**CITY OF CARPINTERIA
ARCHITECTURAL REVIEW BOARD
Meeting of July 29, 2010**

**COMMUNITY DEVELOPMENT DEPARTMENT
PROJECT REVIEW**

Project: 10-1557-ARB
Address: 1290Vallecito Road
APN: 003-171-020
Zoning: Single Family Residential (7-R-1)
Applicant: Tom Ochsner for David Thomas

Project Review: Conceptual
 Preliminary
 Final

Site Plan and Elevations

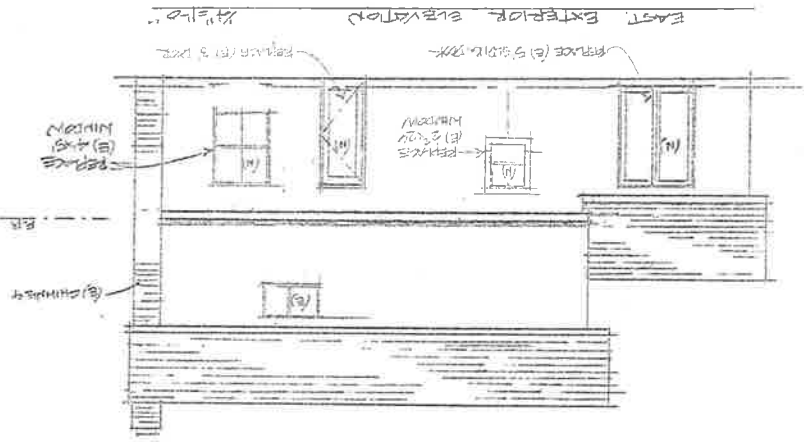
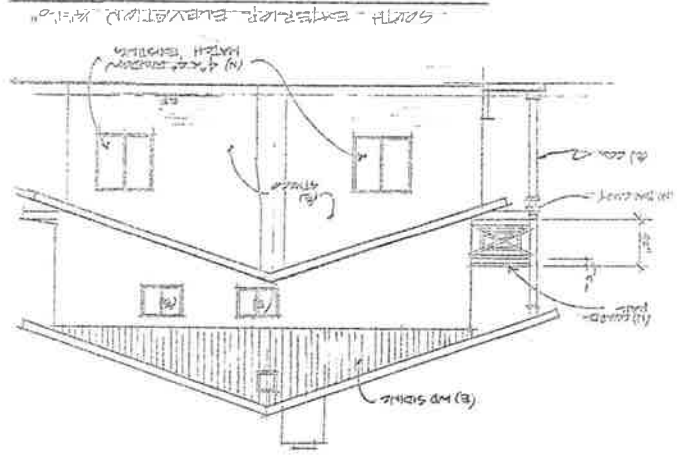
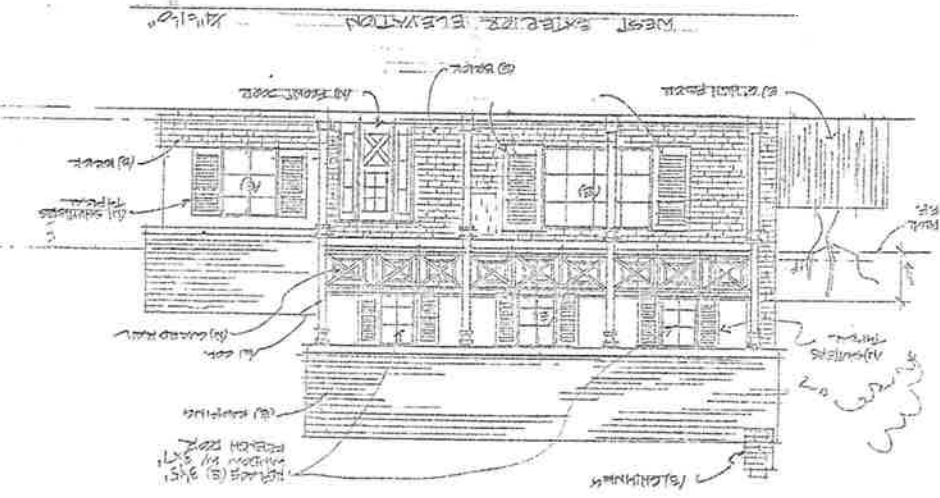
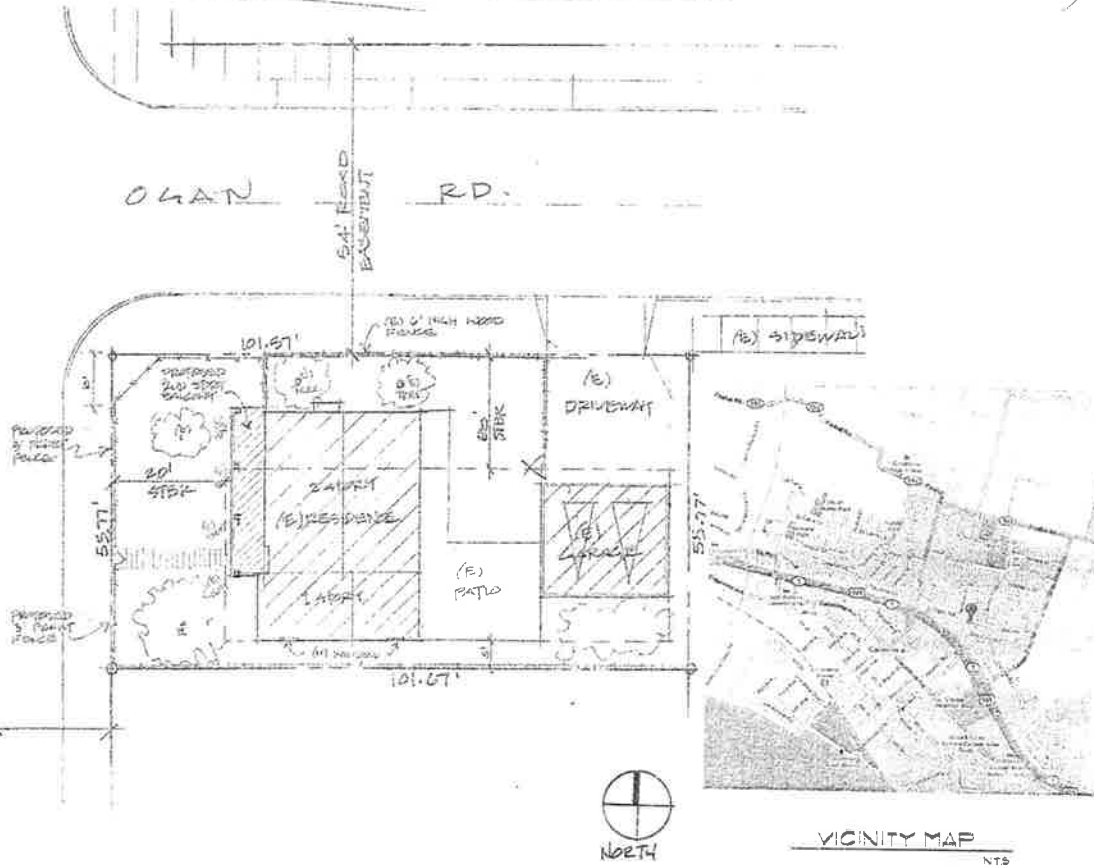
The project proposes to modify the existing frontage elevations of an existing single family residence. The proposal would primarily include the installation of a new second floor balcony facing Vallecito Road. The new balcony would tie onto the existing columns and covered porch which already exists. The project would also include replacement of existing windows and new shutters. Along the North elevation, the project would include a new garage door and garage trim details. The proposal also includes a three foot high picket fence along the street side and front yard. The existing home would be repaired and painted as needed. The existing stucco, brick,

roofing and siding materials will be maintained like existing. The colors will be presented at the meeting. **The Board's comments on the proposed architectural style and detailing of the residence would be appreciated.**

Staff believes that the proposed alterations and modifications to the home can be supported by the above policy objectives. The proposed improvements to the home would introduce architectural details and elements which would soften the bulk of the frontage and bring the home more into scale with other homes in the vicinity. The proposed second floor balcony would help break up the scale of the home and create definition between the first and second floor. The balcony is also in keeping with the Monterey style of the home and roof structures. The new balcony would lend a more balanced element to the column and roof overhang which currently exist.

The project also includes a low picket fence bounding the front yard area. The fence would be set back from the corner of the lot to provide safe visibility to passing vehicles. The fence would be open and allow visibility of the frontage of the home. **Staff requests that the Board consider the proposed changes in the neighborhood setting.**

The proposed architectural improvements consist of the installation of a second floor balcony which is limited to the front elevation of the home. The improvements to the balcony seem appropriate to the style of architecture and would be awkward if wrapped further around the home. The existing materials and exterior treatments will remain as existing and would not be altered with this proposal. Staff requests that the Board consider the use of materials on all sides of the building.

balcony and trim details elements will harmonize with the linear elements of the roof and existing window layout. The proposed balcony is also in keeping with the home's Monterey style of architecture. The proposed fencing and landscaping would be situated along the side and front yards to create a separation of properties while allowing visibility of the front of the home. In general, the proposal is in keeping with the above design guidelines. Staff requests that the Board consider the overall design of the project considering the existing neighborhood pattern.
